MAS004933 RU 25-31

# Rapid Update 623

## Grecale - Premium Alarm System Reactivation

DATE: October 31, 2025

### (OPT LSA) Reactivation (F14 Fuse Restore + VC Writing)

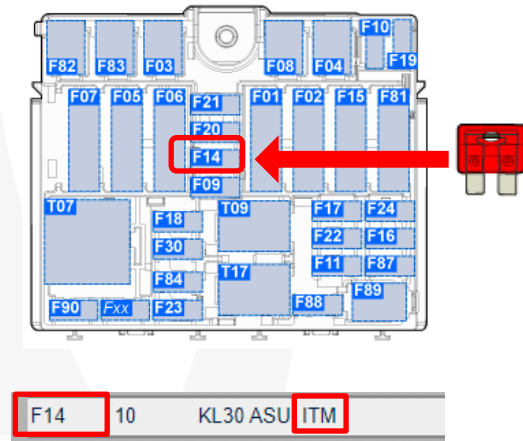
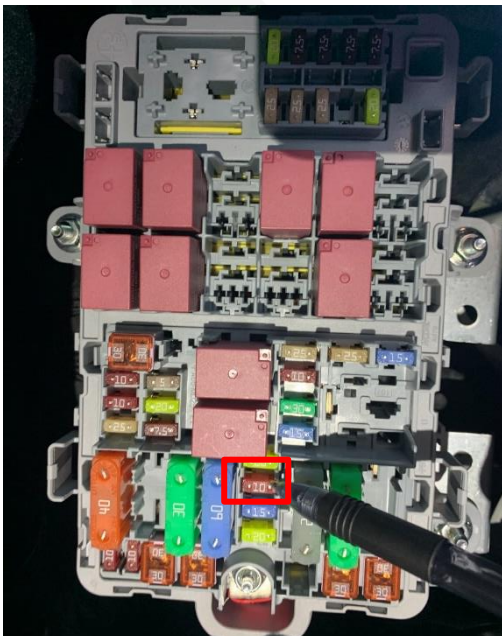
1. Access the Rear Distribution Unit (RDU) and re-install the **F14 10A** fuse that was removed previously per Rapid Update 599, indicated in the pictures below:
